NATIONAL CONSTRUCTION CODE REVIEW

Proposal: Max Brenner - Manly

Location: East Esplanade
Manly

Certis Ref. No: 8146

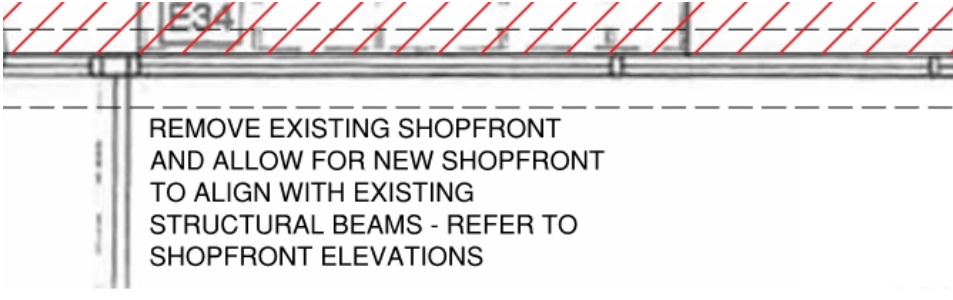
Clause	Title and comments	Status
B1.0 - B1.5	<p>Structural provisions</p> <p>The base building structure is existing. No new load bearing internal walls or rearrangement of any load bearing building elements are proposed . Structural certification to changes on shop front elevations should be considered or install to manufacturers specifications</p>	Note

Table D1.7 | Population

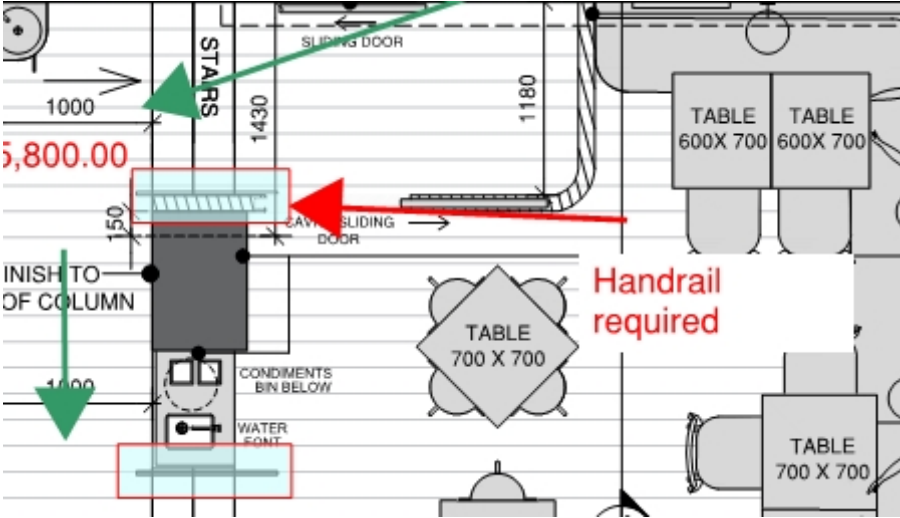
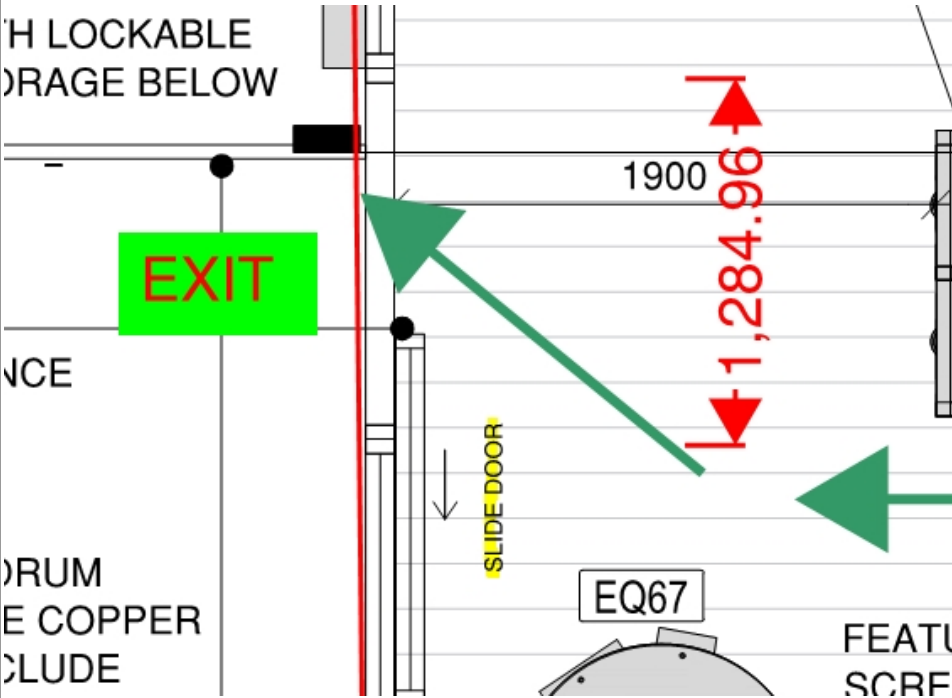
Note - customer or trading floor area (seating) is calculated at 58 sq.m
 The maximum amount of persons permitted to occupy this area would therefore be 58 however internal seating is shown for 53 occupants - complies
